# Work Order ID 88297

Item ID: D3183-043 Accept **\*N900040100\*** Setup Start **\*NS1\***  
 Revision ID: Stop **\*NS2\***  
 Item Name: Bracket Assembly  
 Start Date: 7/27/12 Start Qty: 2.00 **\*2\*** Cust Item ID:  
 Required Date: 7/27/12 Req'd Qty: 2.00 **\*2\*** Customer:  
 Reference:

DESIGN	DRAWN BY	<b>DART AEROSPACE LTD</b> HAWKESBURY, ONTARIO, CANADA	
CHECKED	APPROVED	DRAWING NO. <b>D3183</b>	REV. C SHEET 1 OF 4
DATE	04.02.17	TITLE <b>BRACKET ASSEMBLY</b>	SCALE 1:1
A	03.01.24	NEW ISSUE	
B	03.06.17	REMOVE BEARING; 1.012 WS 0.882	
C	04.02.17	ADD -045/-9; 0.182 WAS 0.431	
C1	04.11.09	0.830 WAS 0.850

DRAWING NO. D3183	TITLE BRACKET ASSEMBLY	REV.C1	DART AEROSPACE LTD ENGINEERING ORDER		D.E.O. NO. D3183-C1-1	SHEET NO. SHEET 1 OF 1	SCALE NTS
DRAWN 92	CHECKED J	MFG. APPR. AA	APPROVED MP		DE APPR. H		
DATE 10.05.14	DATE 10.06.30	DATE 10.06.30	DATE 10/06/30		DATE 10/06/30

**D3183-5 BEARING:**  
**SPECIFICATION CONTROL DRAWING**

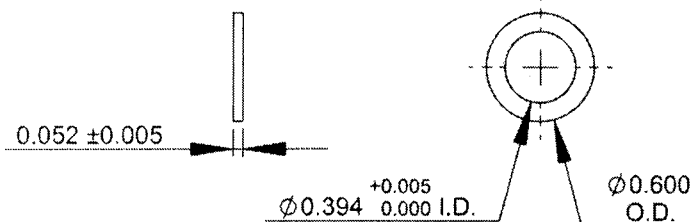
D3183-5 BEARING

ADD POSSIBLE SUPPLIER: KML P/N 6800-ZZ

BASIC LOAD RATING REQUIREMENT:

Cr = 1720 N (386 lb) MIN [DYNAMIC]

Cor = 840 N (188 lb) MIN [STATIC]
